12-BSTD-1

Re: March 12, 2012 45-day Language Hearing for Nonresidential Buildings - 2013 Building Energy Efficiency Standards (AHRI Comments on §140.4(e)4; Docket # 12-BSTD-1)

Title 24 Economizer Change Background

Drybulb Tolerances

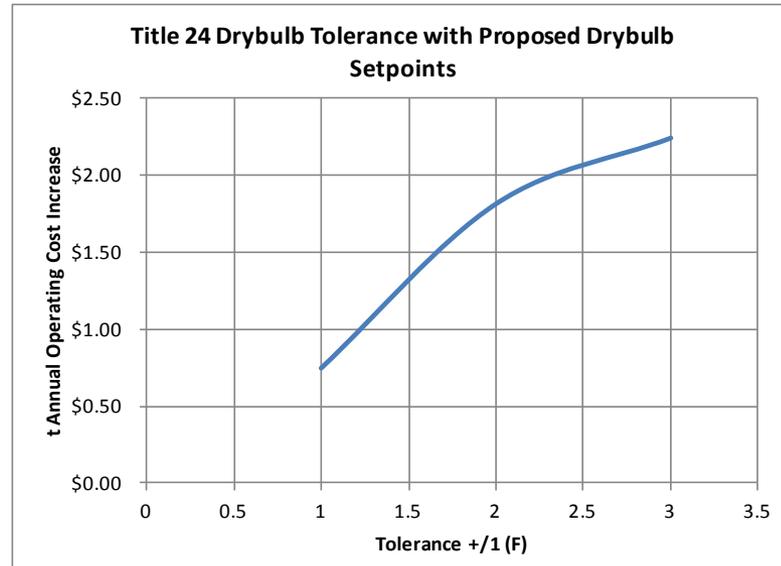
- Taking the prior chart you can then plot the operating cost increase as a function of the 1, 2, and 3 °F tolerance.

- As you can see if we doubled the tolerance to ± 2 °F the operating cost on average only increased \$1.75 per year for the 7 ton system
- Assuming a base cost for the sensor of \$20 and that the ± 1 °F tolerance would double the cost it would have a payback of 11.4 years using the ASHRAE 90.1 power cost. This is well beyond a reasonable payback.
- **We recommend to tolerance be increased to ± 2 °F for a temperature range of 60 to 80 F ambient temperatures**

Peak Enthalpy Changeover Setpoint

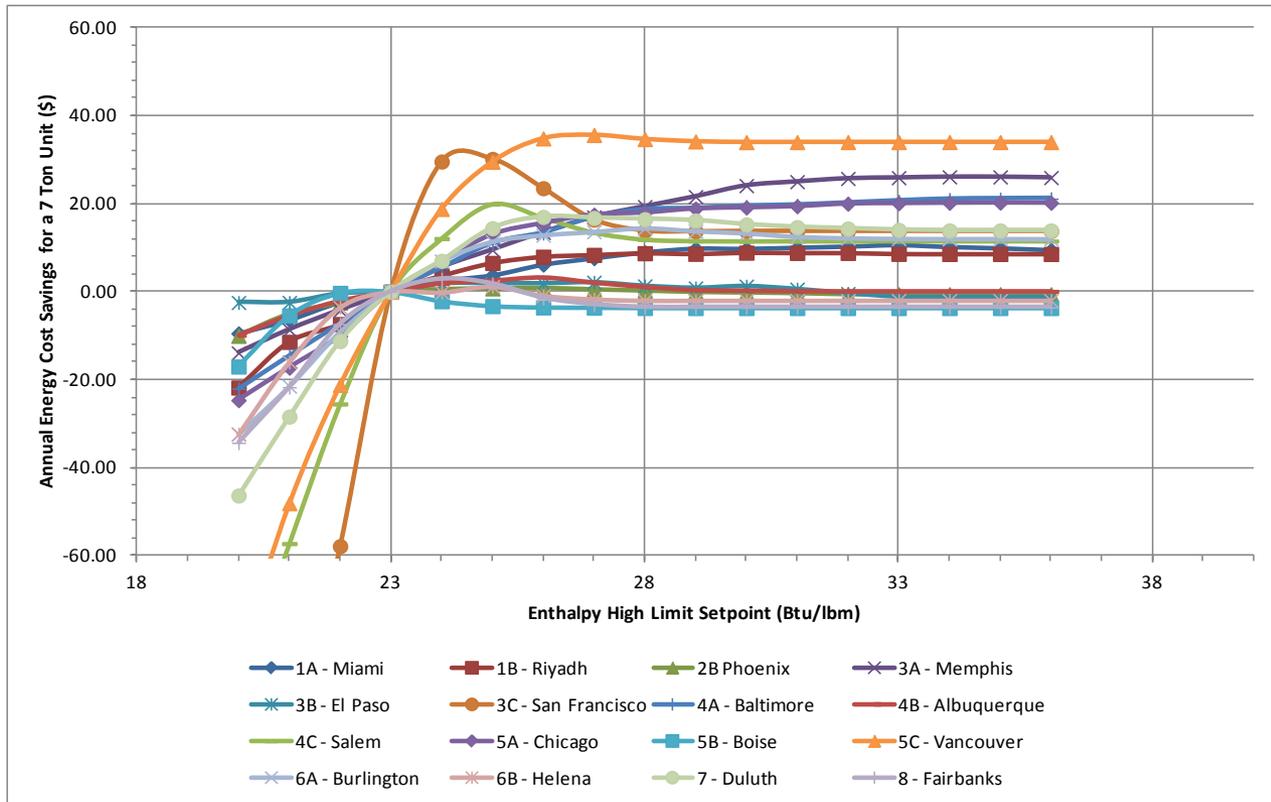
- The following is a plot of the energy savings.
- Again it shows that in the range of a 28 Btu/lbm setpoint that the curves are flat and changes or tolerances will not have a big impact.

Enthalpy Tolerances

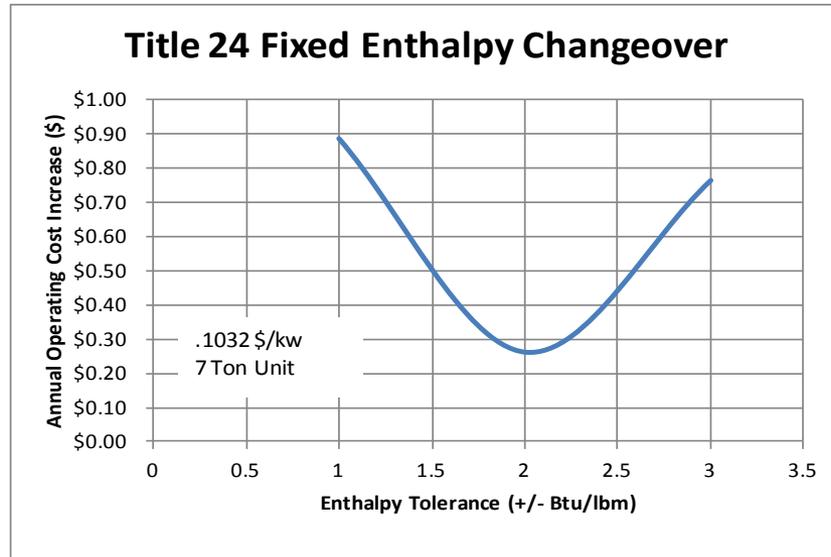
- Taking the prior chart you can then plot the operating cost increase as a function of the 1, 2, and 3 Btu/lbm tolerance.

- As you can see if we triple the tolerance to +/- 3 Btu/lbm that the operating cost increase vs. zero tolerance is only \$.76 per year.
- Vs the 1 Btu/lbm tolerance the 3 Btu/lbm tolerance is actual lower in energy cost impact as the 28 Btu/lbm is not the optimum.
- **We recommend to tolerance be increased to ± 3 Btu/lbm for a range of enthalpy of temperature range of 25 to 35 Btu/lbm enthalpies.**

Peak Differential Drybulb Offset Setpoint

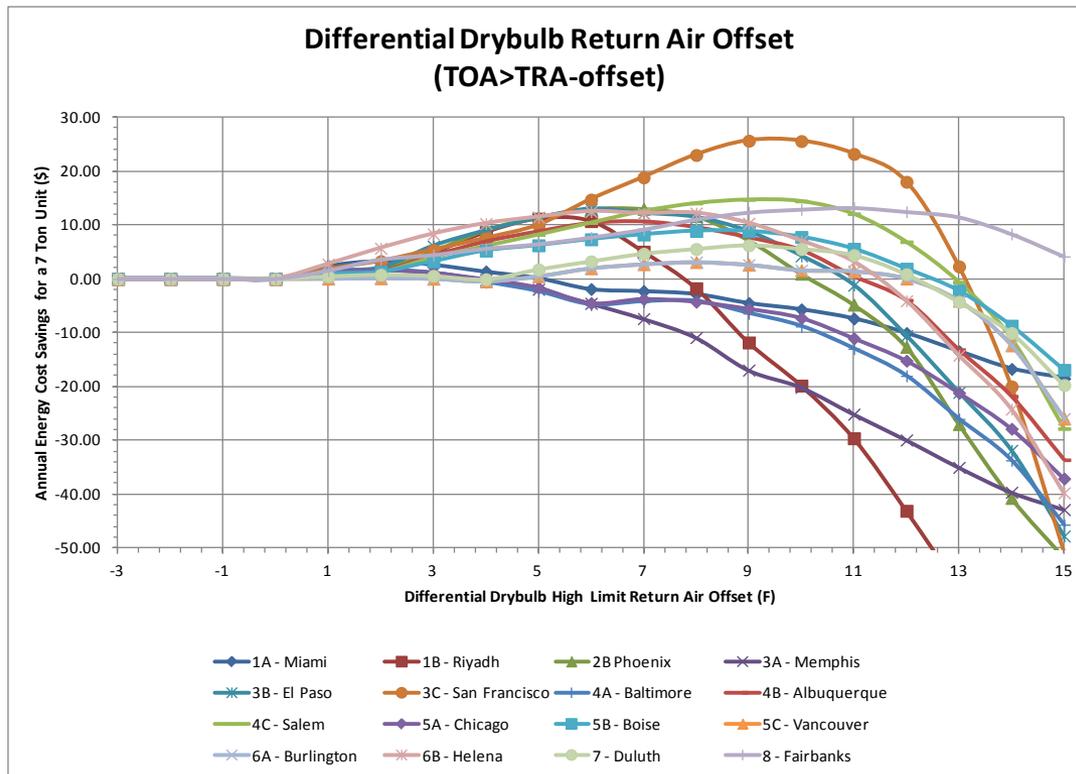
- The following is a plot of the energy savings for the differential drybulb changeover relative to the return air offset of 0 °F .

- This has more of a peak than pure drybulb, but there is a flat spot for each climate zone of 4 – 5 °F.

Differential Drybulb Tolerance Study

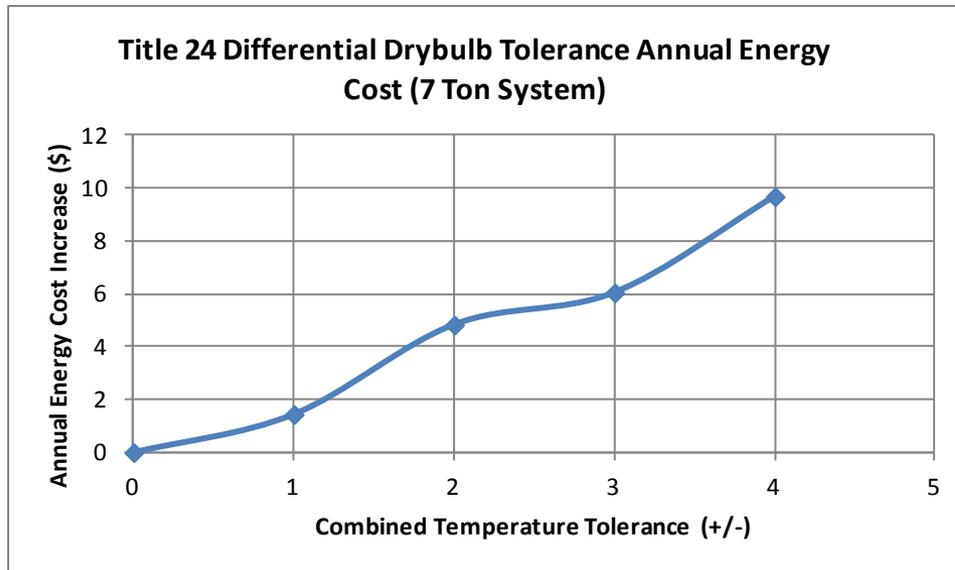
- The following is a plot of the prior chart on differential tolerances.

- We feel that a combined tolerance for the differential of ± 3 °F would be appropriate. This is slightly tighter than combined error of two sensors with a ± 2 °F but it would encourage the development of differential sensors.
- We are checking with suppliers of sensors to get their feedback, but even a ± 4 °F would not be much of a cost penalty.
